**OU1 Design Change and Modification Sheet:
Change/Modification # 40**

Property ID: _____ Operable Unit 1, Area 1

Reference Sheet C6A, Titled OU1-Remedial Action, Proposed Final Grading and Restoration Plan (Search and Rescue Area). As the result of unseasonably heavy rains the drainage system was overwhelmed and a portion of the new City Services Road flooded. The portion of the road which flooded is by design the low point in the road. There are two rock trench drains in this area. One on either side of the roadway. Both of the drains were built as designed (see attached detail sheet) but failed to be capable of handling the volume of water which resulted from the event, thereby allowing the road to flood. On July 17, 2012, the City of Libby formally requested help from the EPA to correct the issue. A determination was made that the drains had to be significantly deepened to facilitate a greater volume of water. The west drain was dug to a depth of approximately 8' at which point ground water was encountered. The width of the drain was increased to a width of approximately 14', with the length remaining at the design length of 20'. The smaller drain on the east side of the road

PORTION OF SHIT C6A

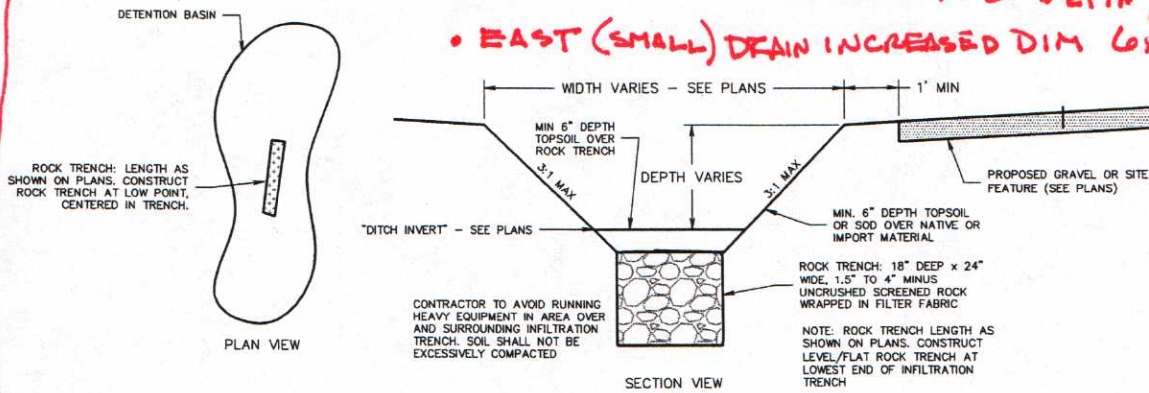
APPROX. AREA OF
FLOODING

ROCK DRAINS

20 LF ROCK TRENCH
DITCH INV 64.25

10 LF ROCK TRENCH
DITCH INV 65.00

- WEST (LARGE) DRAIN INCREASED DIM. 14' x 20' x 8' DEPTH
- EAST (SMALL) DRAIN INCREASED DIM 6' x 10' x 6' DEPTH

TYPICAL DETENTION BASIN/ROCK TRENCH

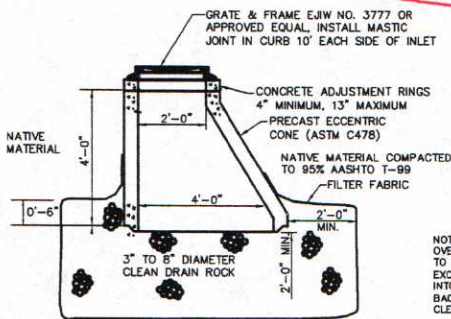
See attached drawing(s) for location of drains/flooding and the designed rock trench detail.
